Access Compliance Report

Public Rights-of-Way

(Curb Ramps)

| Intersection ID: 6957 | Main Street: N_TRYON_ST | Cross Street: N_US_29_BY-PASS_HY | Location: NW |

| ADA ID: 8BFA7D3F4017 | Ramp Type: Perp | Initial Pass/Fail: Fail | Overall Compliance: No |

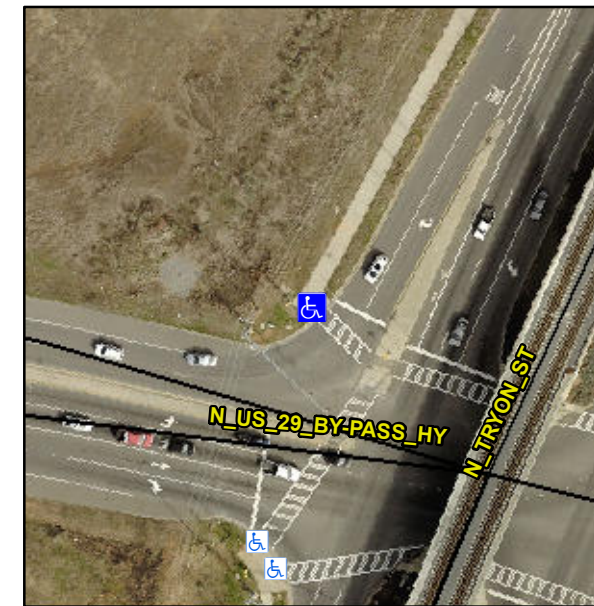
Not Found, R304.5.1, R304.5.3

| Compliance | Description | Data | Compliance | Description | Data |
|------------|-----------------------|-------|------------|-----------------------------|------|
| No | Ramp Width (in) | 47.5 | No | Ramp XSlope (%) | 5.9 |

Remove & Replace Entire Ramp.
